**NOTICE OF ADDENDUM
ADDENDUM NO. 2**

**CONTRACT NO. 7939
MADISON MUNICIPAL BUILDING - RENOVATION**

This addendum is issued to modify, explain or correct the original Drawings, Specifications, or Contract Documents and is hereby made a part of the contract documents.

3 LEVEL 2 - W11 - SILL DETAIL
 A652 3' = 1'-0"

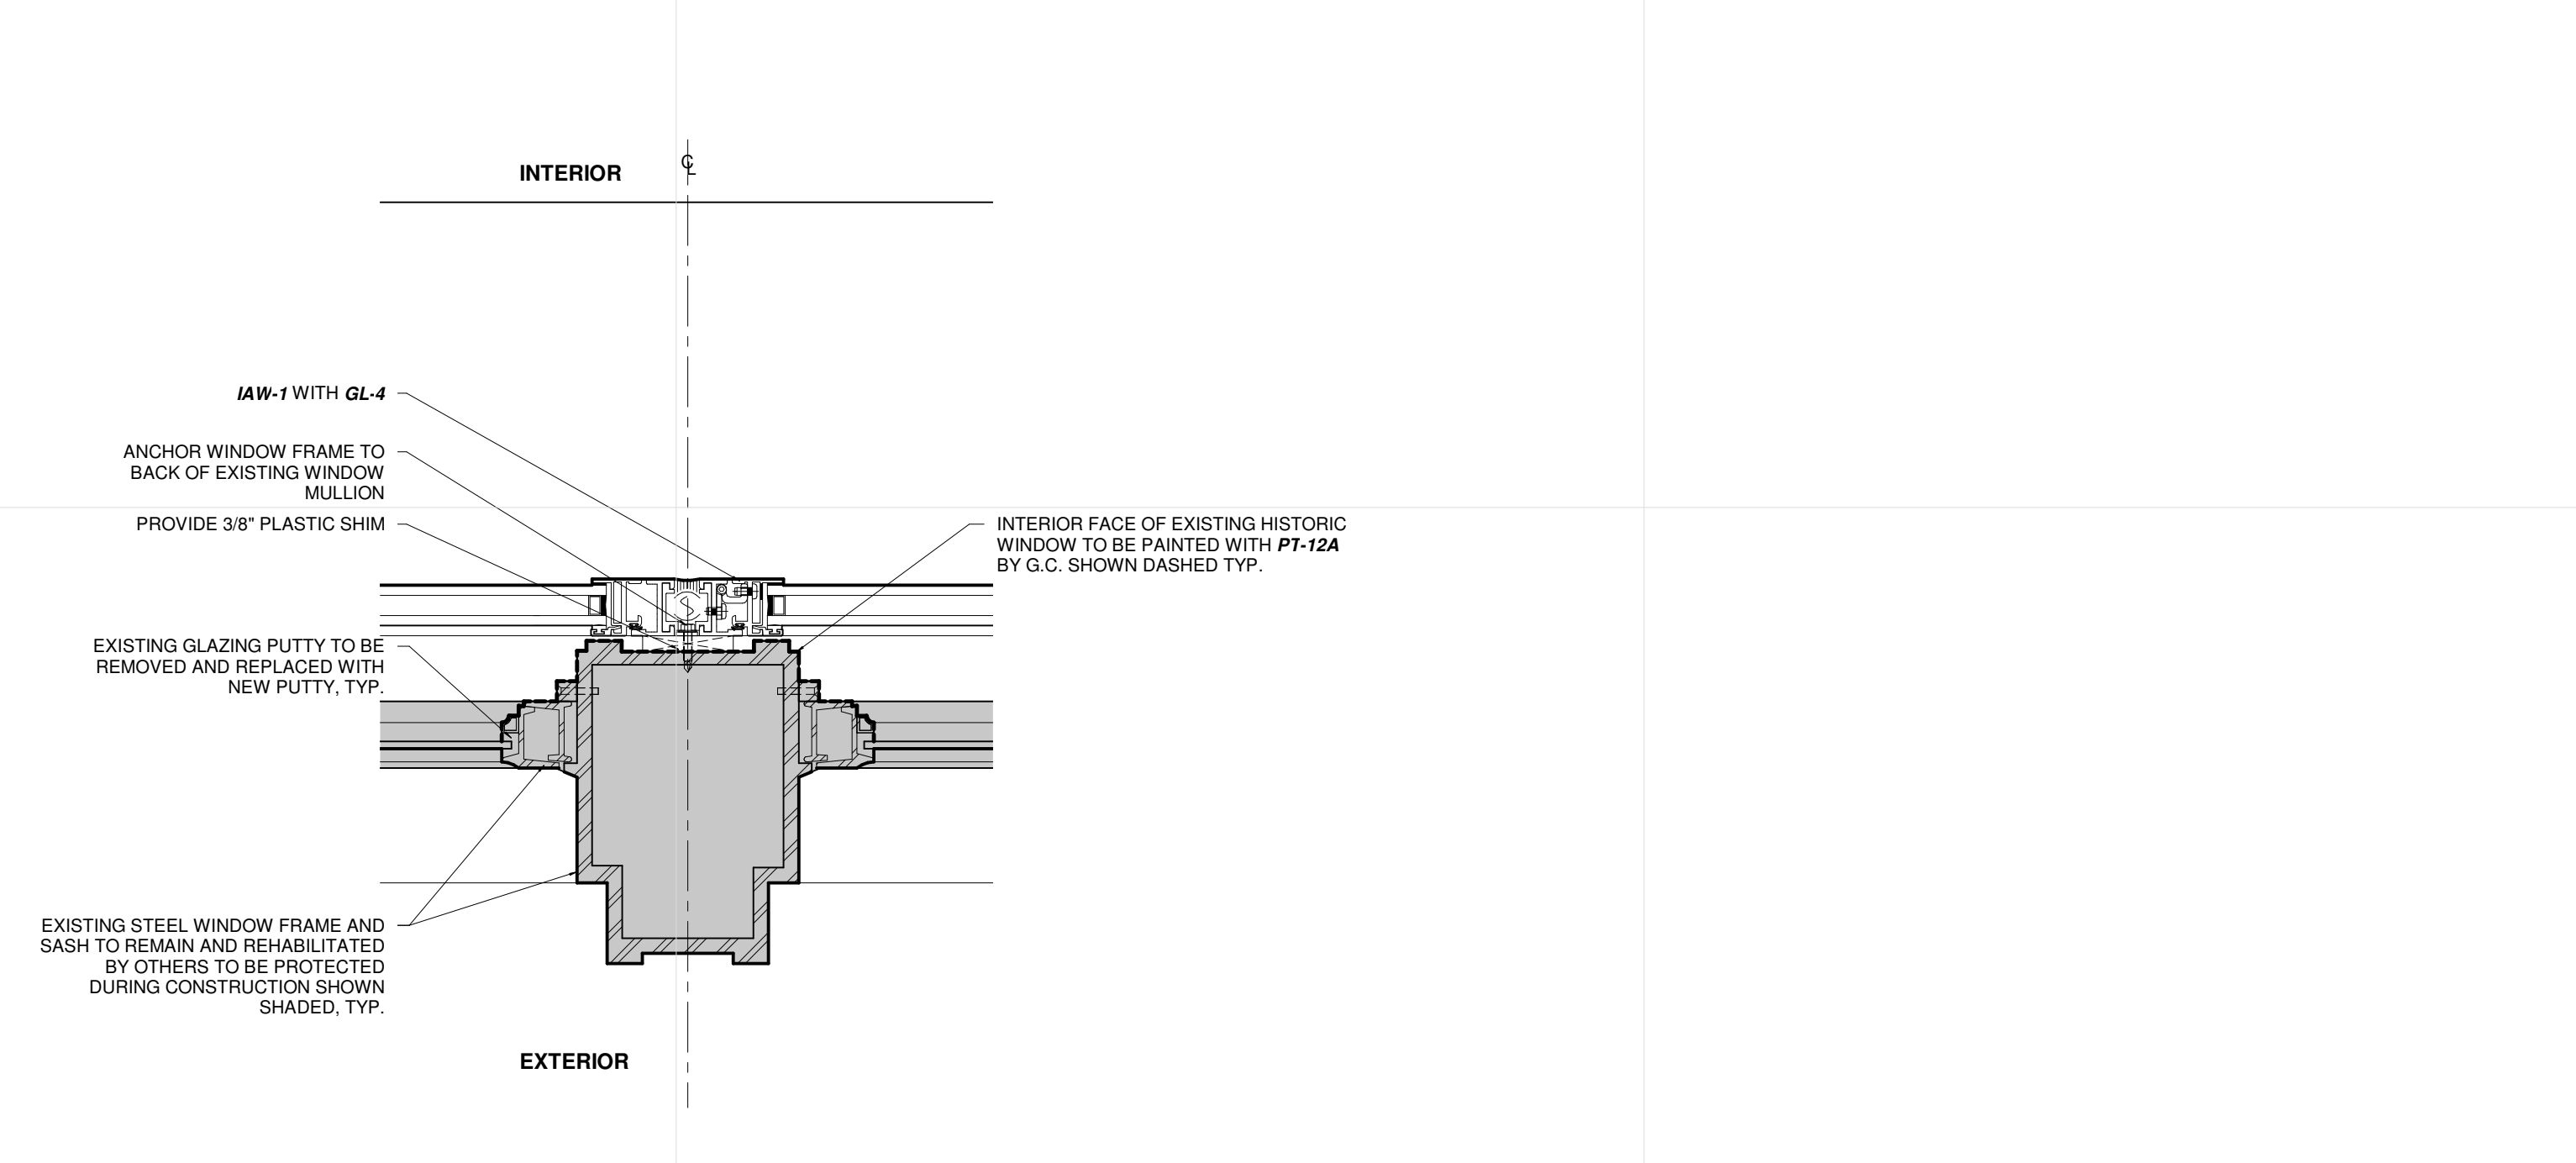
4. Details A620 through A624, and A651 through A654. Due to durability and cost concerns regarding the new metal window stools, these have been changed from MTL-3 to solid surface material SSF-3.
5. BE001. Amend general note 10 on sheet BE001 (drawing); Add language to general note 16 on sheet BE001 (drawing)
6. BE219. Revised stone numbers
7. BE338. See Clarifications Section below
8. BE356. See Clarifications Section Below
9. BE356.1. See Clarifications Section Below
10. BE356.2. See Clarifications Section Below
11. S101. See Structural Memo Attached.
12. S102. See Structural Memo Attached.
13. S103. See Structural Memo Attached.
14. S104. See Structural Memo Attached.
15. S190. See Structural Memo Attached.
16. S201. See Structural Memo Attached.
17. S302. See Structural Memo Attached.
18. S304. See Structural Memo Attached.
19. E300. See MEP Memo Attached.

EXHIBIT F
BE356

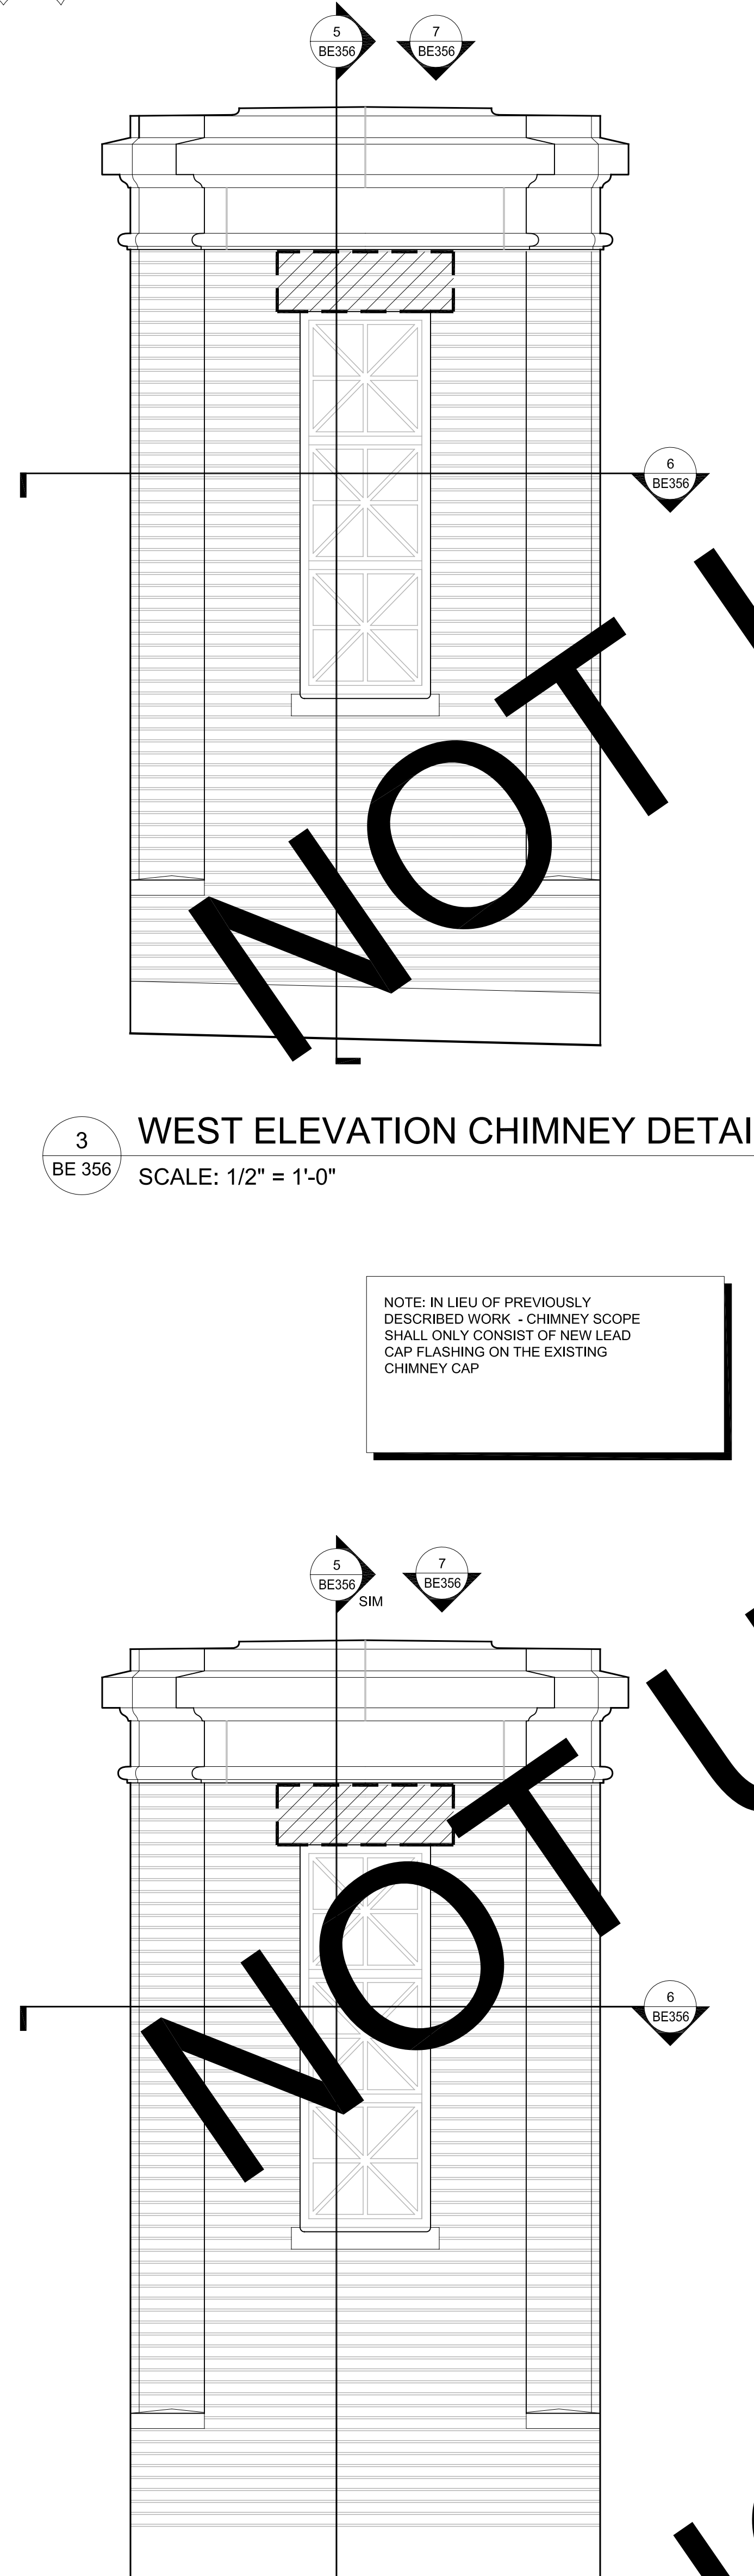
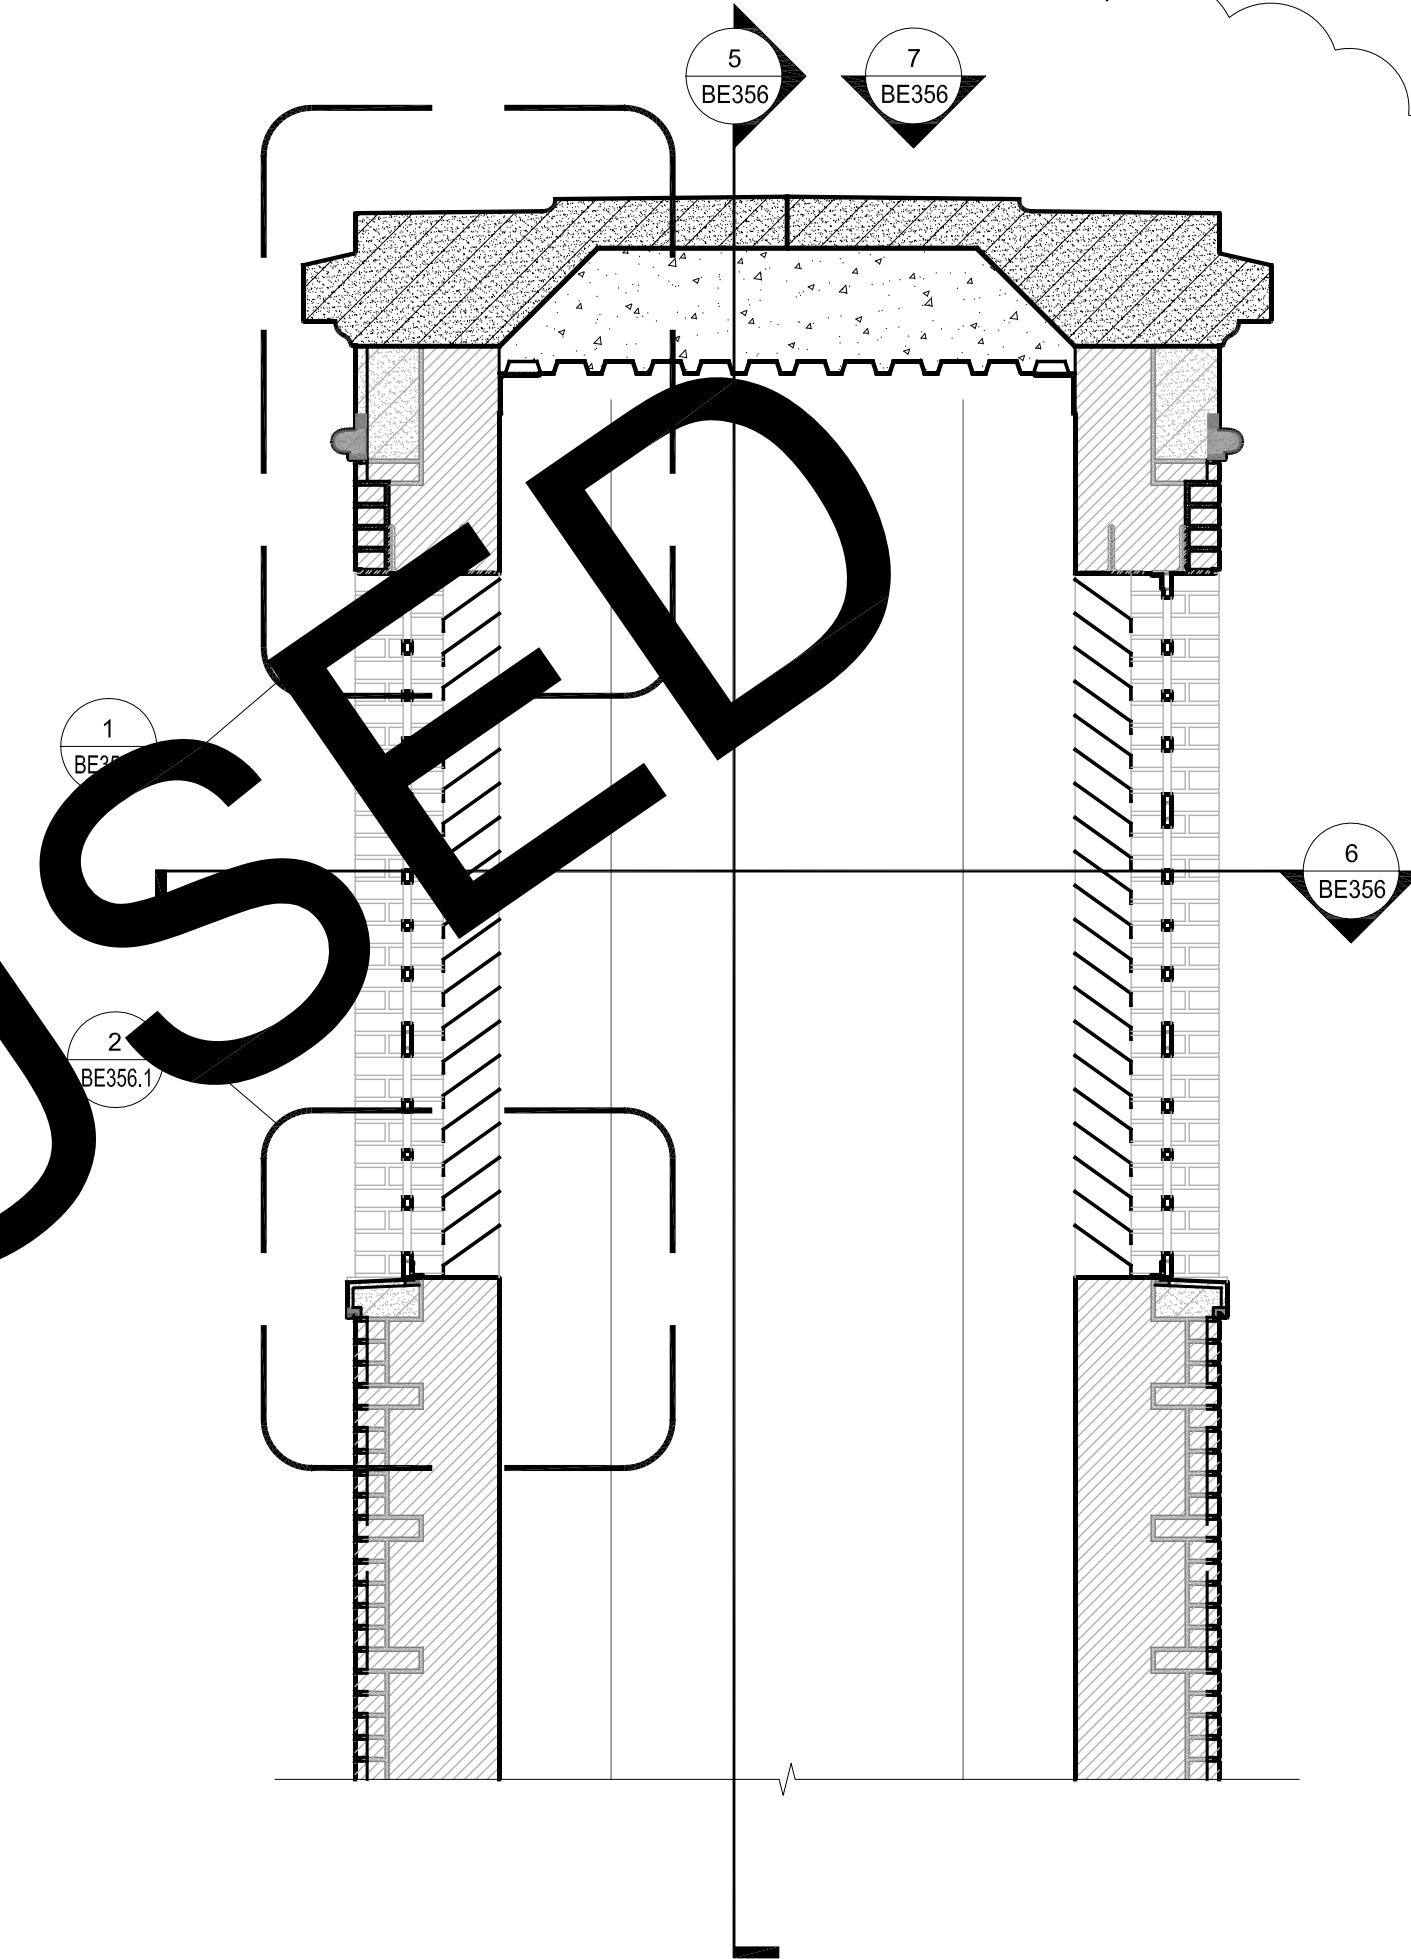
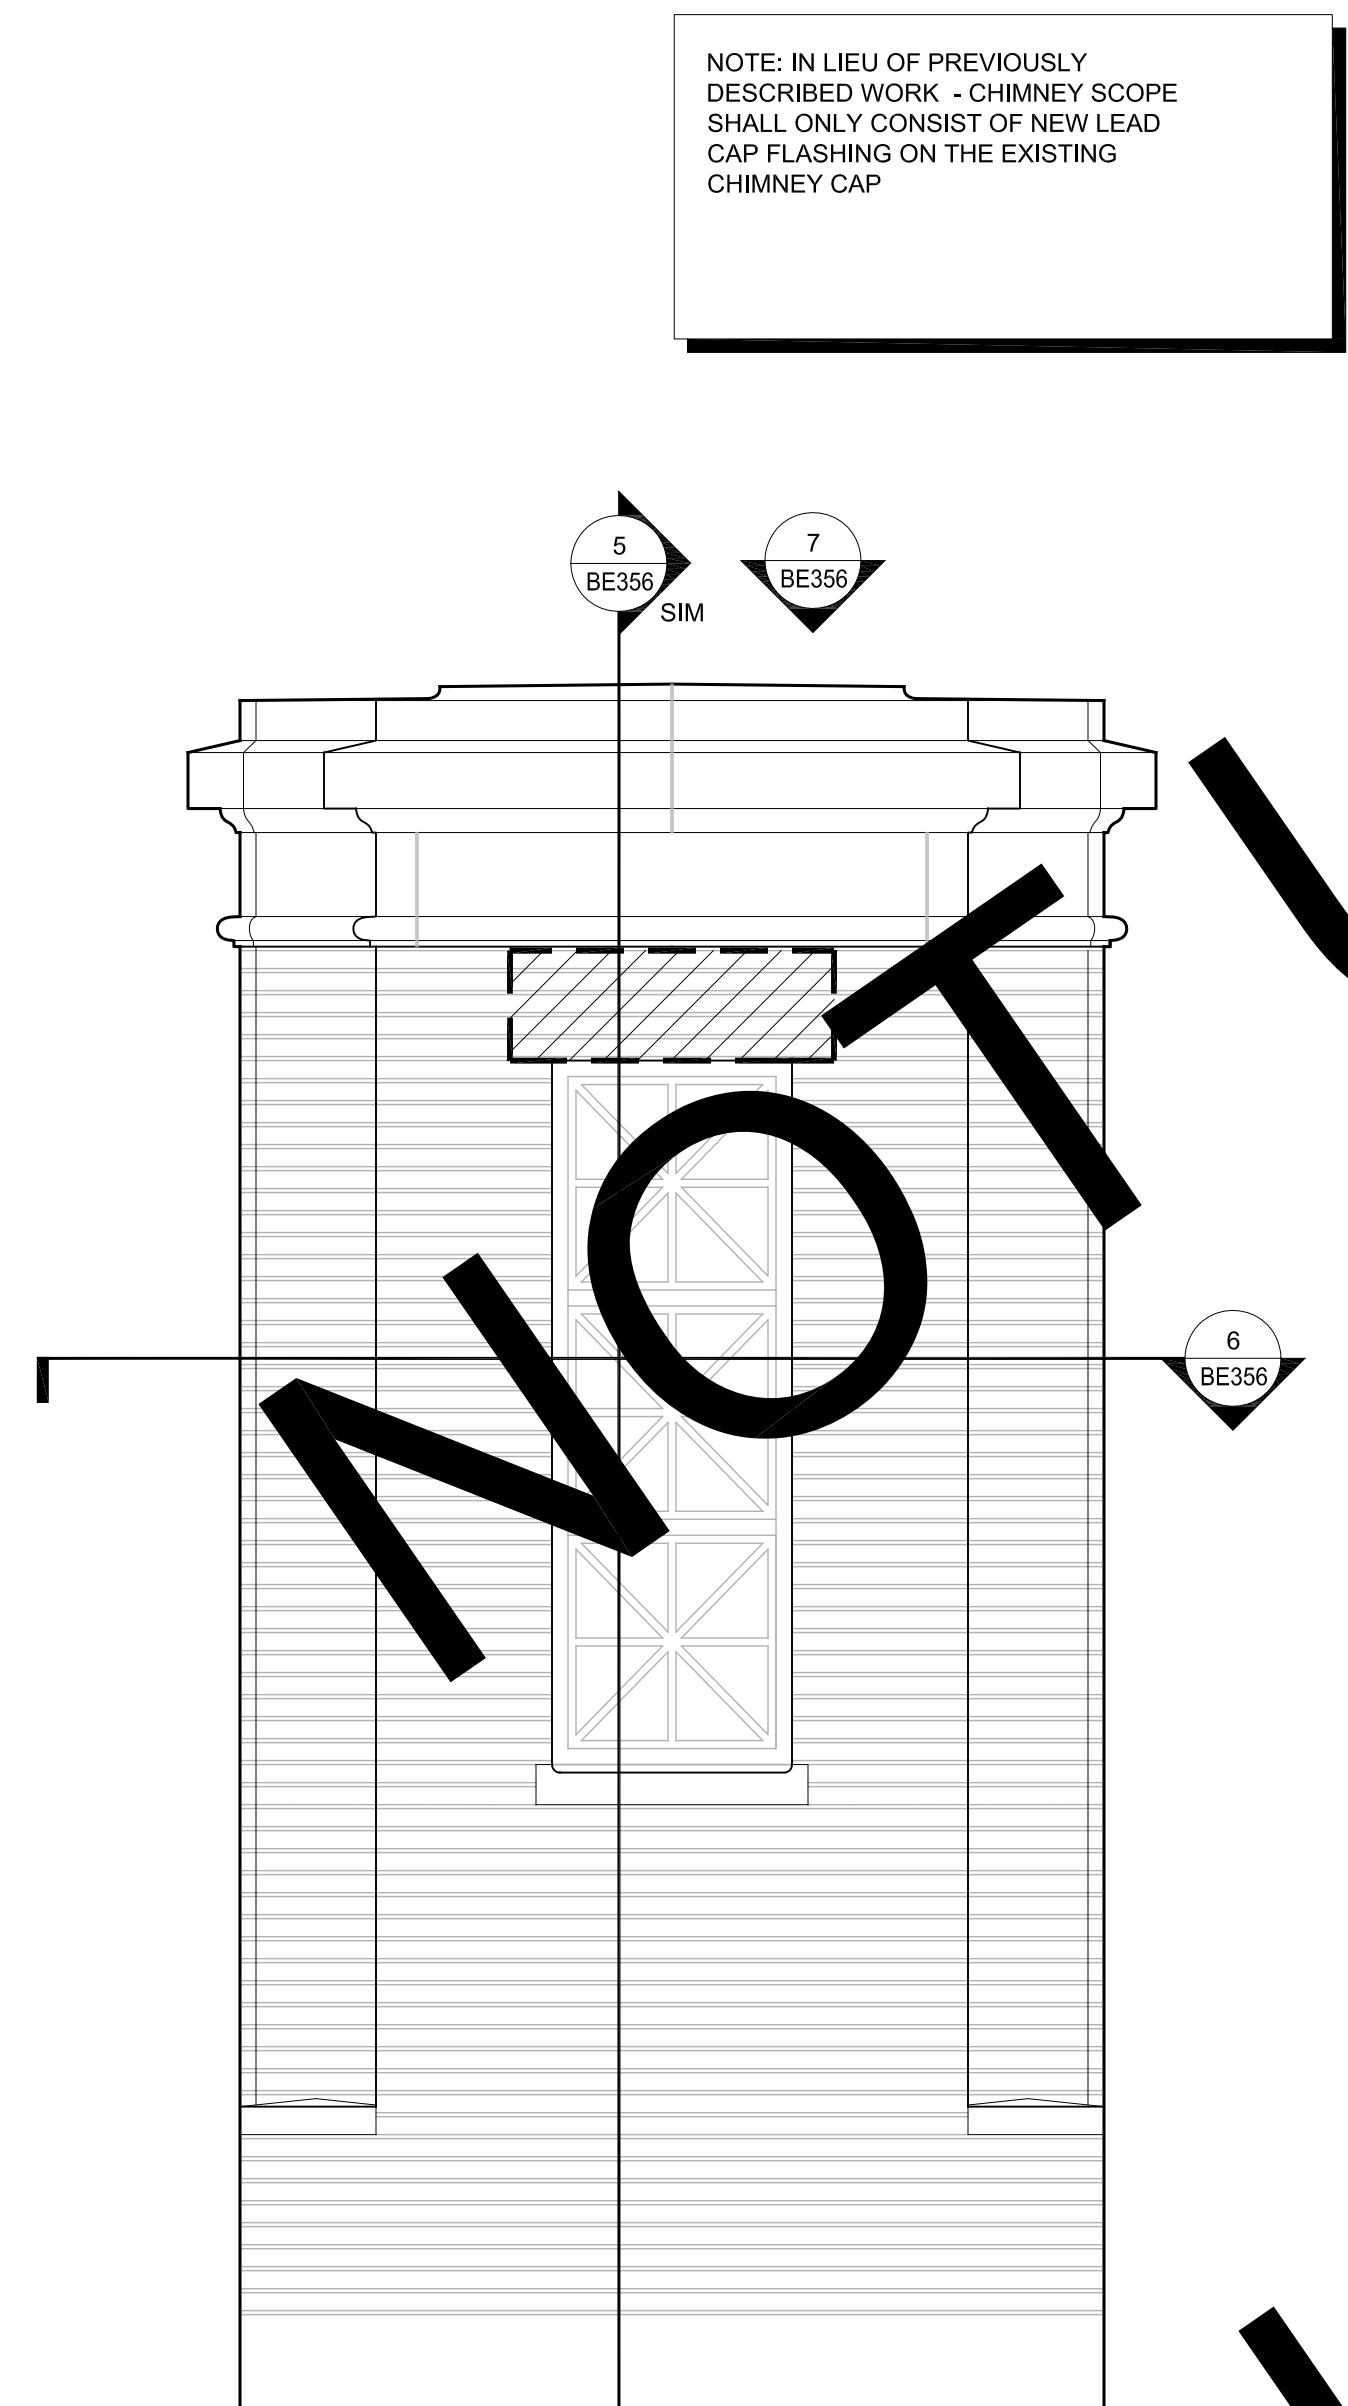
Answer: See revised Exhibit G attached with this Addendum.
14. **Question:** Sheet BE356 detail 7 states to reuse existing chimney cap while detail 1/BE356.1 (and elevations on A201) state to provide a new cap. Please clarify if we are to reuse or provide a new chimney cap.

NOTE: IN LIEU OF PREVIOUSLY DESCRIBED WORK - CHIMNEY SCOPE SHALL ONLY CONSIST OF NEW LEAD CAP FLASHING ON THE EXISTING CHIMNEY CAP
